**SUBJECT: SAFETY RECALL OF 2022~2024 MB TOURRIDER COACHES**

Ref.: **NHTSA recall reference #: 24V-151**  
**DCNA Bulletin # TI 83.10T24281A**

**TI No.: 83.10T24281A**

**TITLE:** **Tourrider USA - Replacing the operating levers of the emergency exit hatches**

M83.10-A019-80

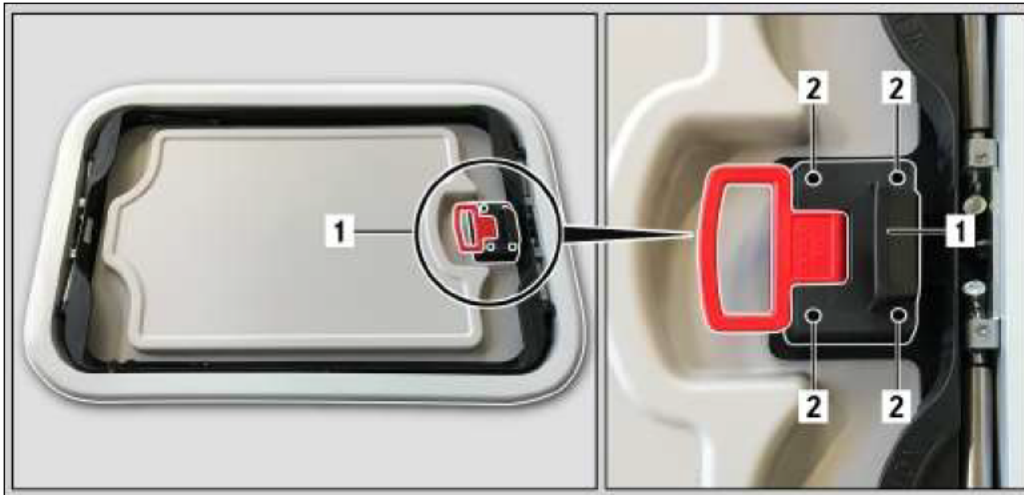
The operating levers of the emergency exit hatches could break.

Inadequate material strength of the operating levers.

Fit an optimised version of the operating levers.

1. Remove screws **(2)**.
2. Remove operating lever **(1)**.
3. Fit the new operating lever and fasten in place.

2 Nm

4. Open and close the emergency exit hatch 2-3 times to ensure trouble-free operation.
